RE: ENGINEER CERTIFICATION FOR LEECO @ JOURNAL CENTER (D-17/D3C)
CERTIFICATION STATEMENT DATED DECEMBER 12, 1990

LEECO
at JOURNAL CENTER

REVISED
DRAINAGE PLAN

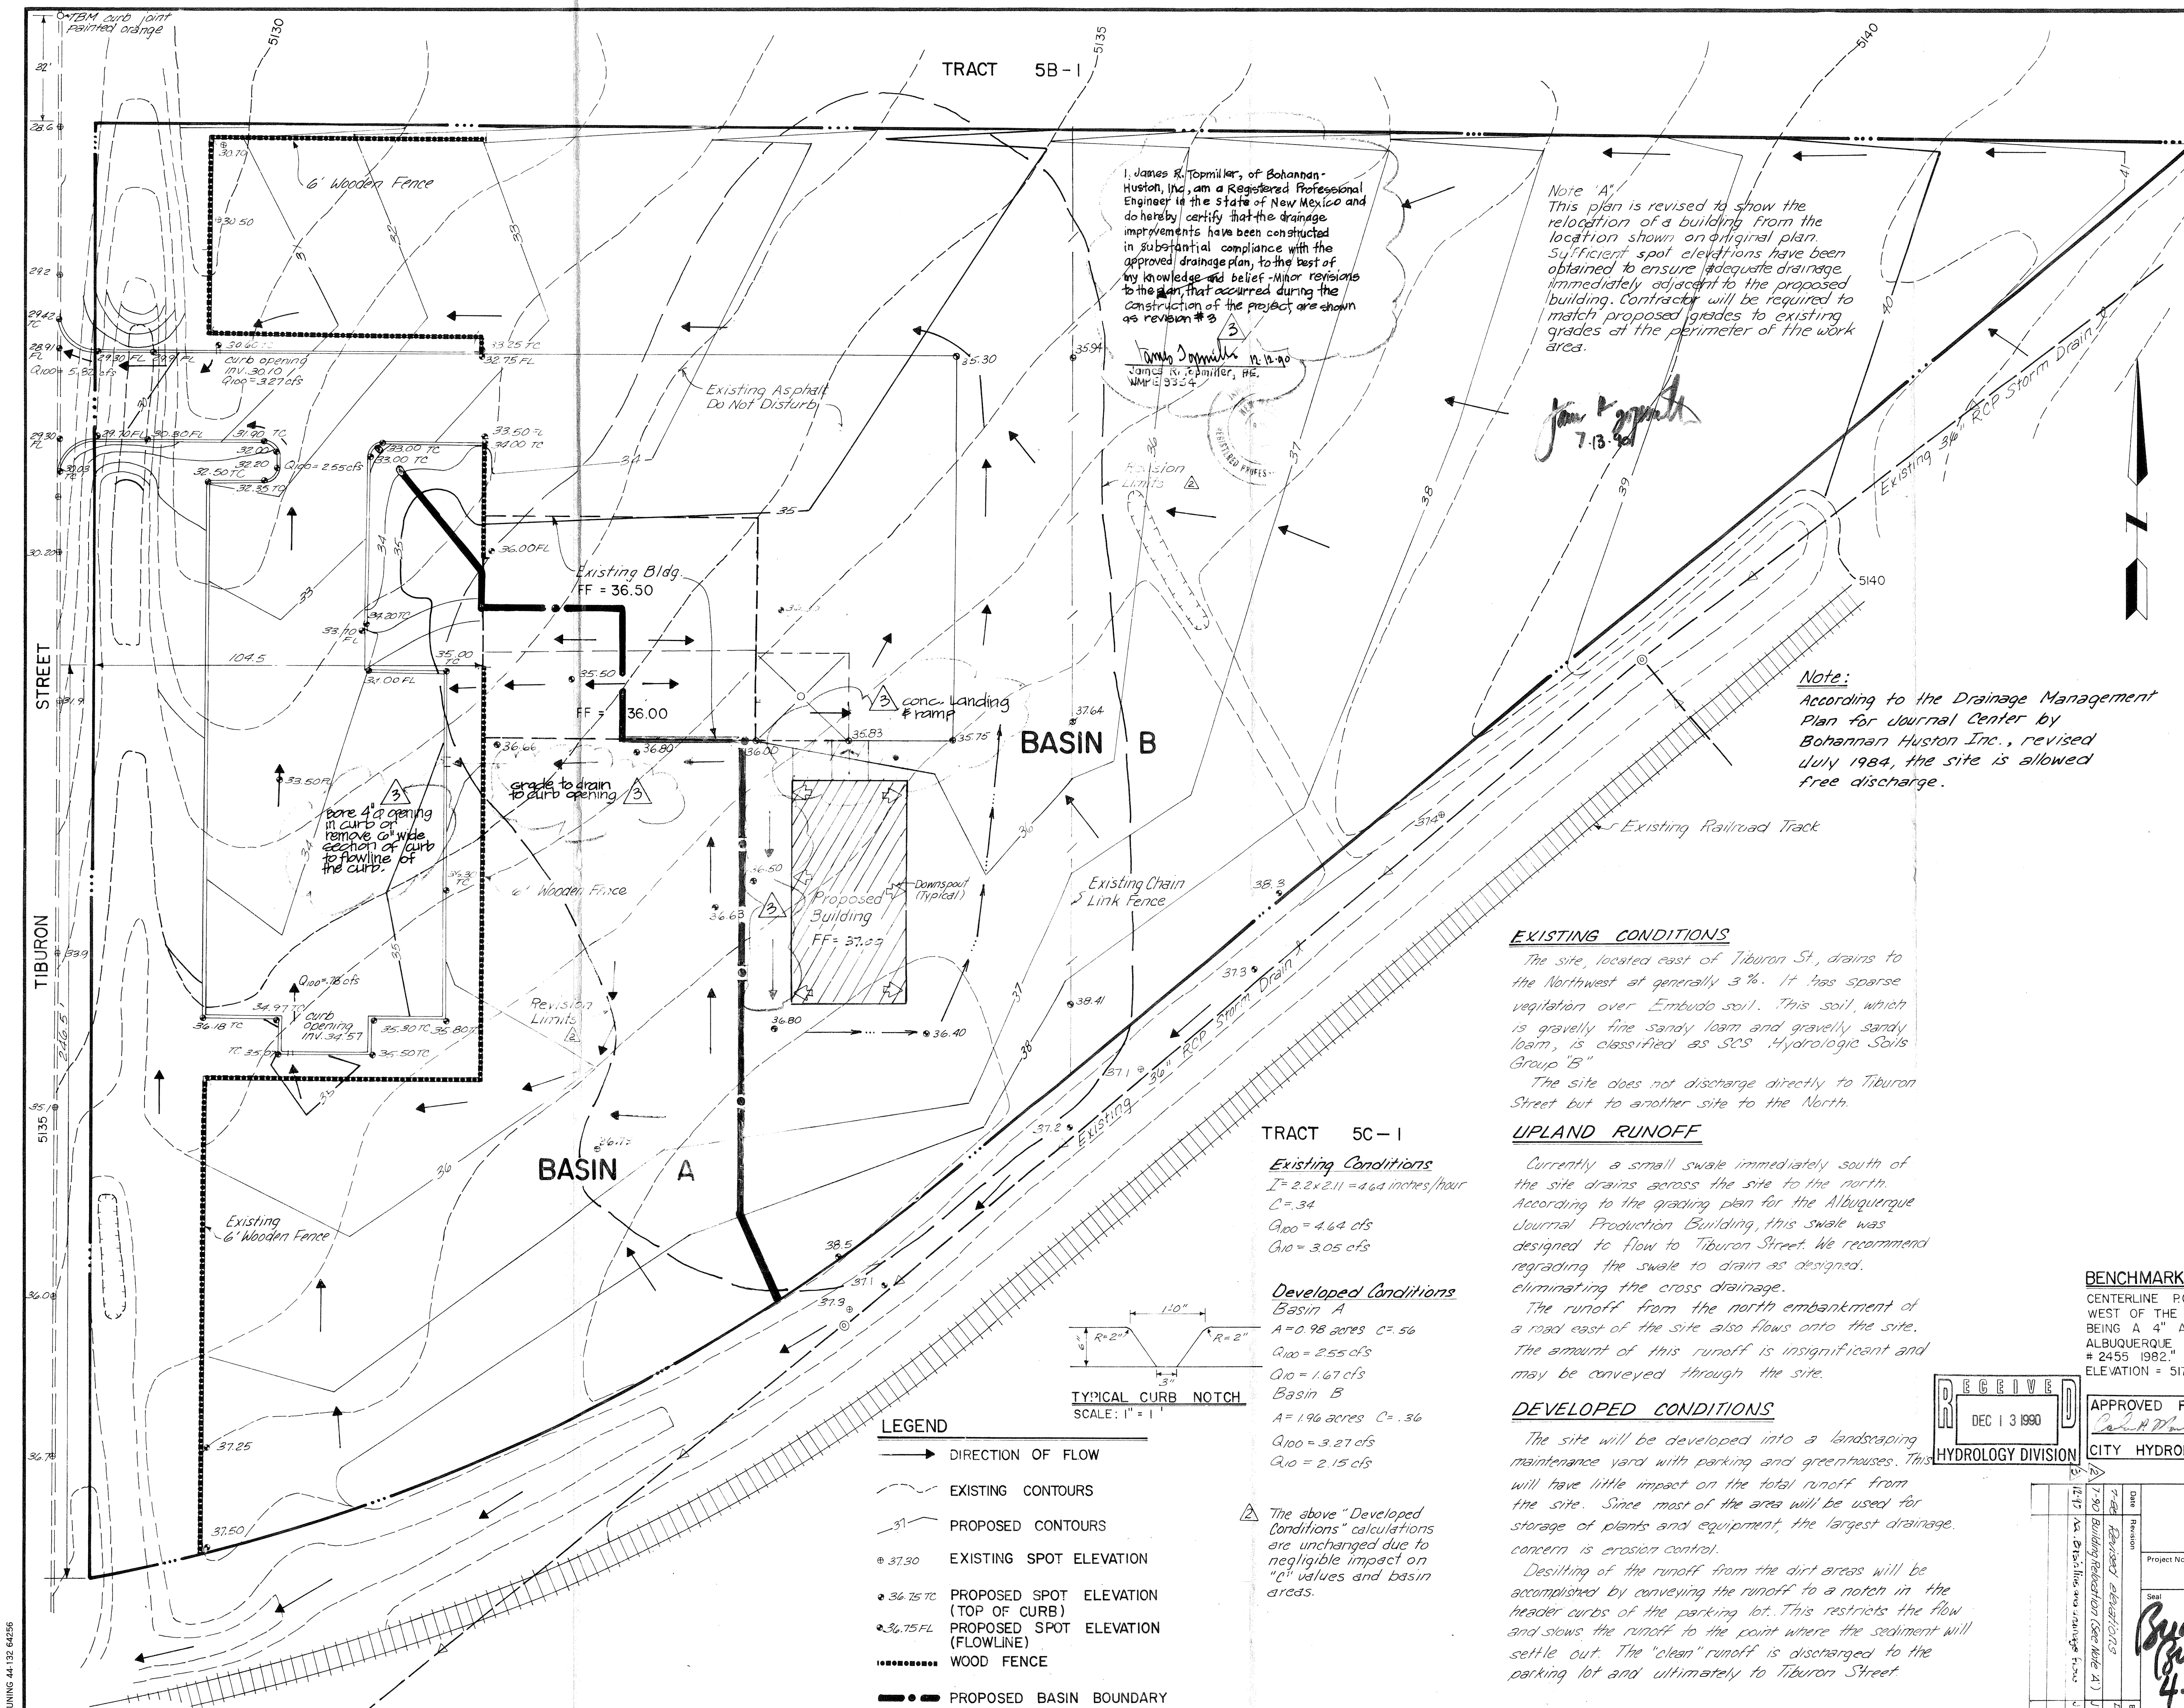
Based on the information provided on your December 13, 1990 submittal, Certification for the above referenced site is acceptable.
